Urgent Field Safety Notice

Subject: Evolution series beds until manufacturing date December 31, 1999

FSCA-identifier Mod 388a

Type of action Verification of the side-rail gaps

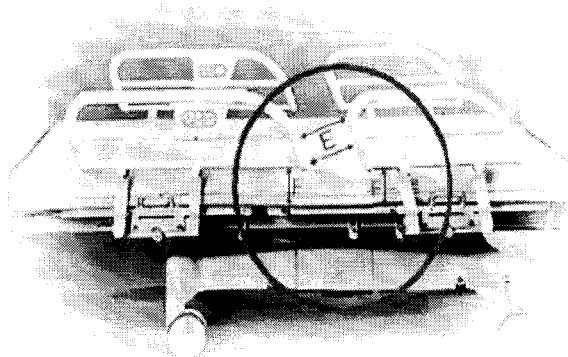
Of particular importance is the gap "E" between the two siderails and gap "F" between lower side rail bar and sleep surface.

The accepted guidelines for this gap measurement are:

- **Gap E \geq 235 mm**
- **Gap F \leq 60 mm**

Any bed that has not been refitted by an appropriate siderail kit will not meet the essential requirements of the § 7 MPG and must be removed from service.

Please consider that non compliant siderails can cause high risks for entrapments. A Patient with a small size and/or weight is small enough to pass through the space and to become trapped between the siderails - with potential serious injury or death.

- Please check the side rail gaps against the above mentioned details and the safety advice from the highest regional authorities (Medical device bulletin 1/2001; Check list Appendix 2)
- In order to meet the legal requirements Hill-Rom will provide retrofit kits which fit precisely to the different side rail versions.
- Please contact Hill-Rom in any case in order to inform us about the results of your side rail verification.
- If you have moved your beds to another location, or if any beds have been sold or removed from service, please advise us immediately so that we take appropriate steps to complete this action.
